**SUBDIVISION COMMITTEE  
METROPOLITAN AREA PLANNING COMMISSION**

STAFF REPORT  
(Preliminary Plat)

CASE NUMBER: S/D 90-68 - THE MOORINGS 6TH ADDITION

VICINITY MAP:

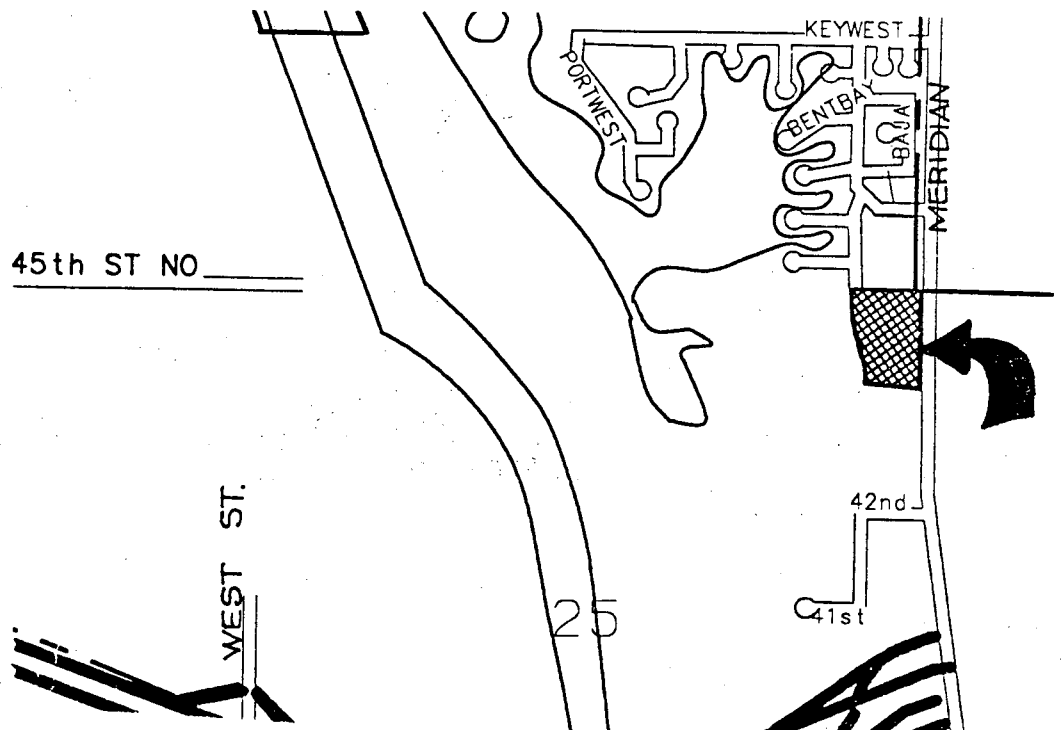
- L. On the final plat, the word "Complete" should be dropped from the face of the plat where "Access Control Except for Two Openings" is being indicated.

- M. On the final plat additional dimensions shall be provided to better locate the proposed water line easement indicated at the southern end of the plat. This should include dimensions from the southeast and southwest corners of the plat to the easement and additional dimensions along the easement itself.
